## 16089E-01

# S E R V I C E N O T E

## 16089E – Kelvin IC Clip Lead

16089E Kelvin Clip Lead - Semi Opaque “Rubber band” Replacement Part.

Figure 1-1 Clip

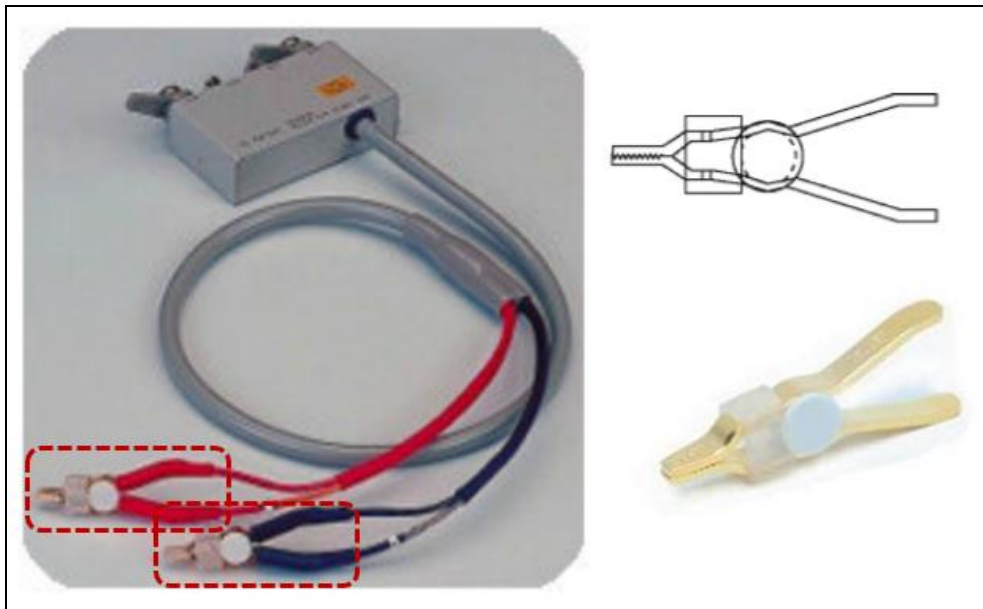
Shown in figure 1-1 is the sample image of **8710-2158** Clip for reference only. Heat shrink tubing 0890-2295 (black color) and 0890-2296 (red color) are not included. It is not recommended to replace the whole clip since the clip replacement requires soldering.

Keysight PN is **8710-2158** Clip.

With the new clip on hand, remove the semi-opaque rubber band from the new clip(s) in replacing the worn out/ torn rubber band of the old clip(s). Purchase **8710-2158** (Qty. 2) in replacing the two worn out/ torn rubber bands for each 16089E.
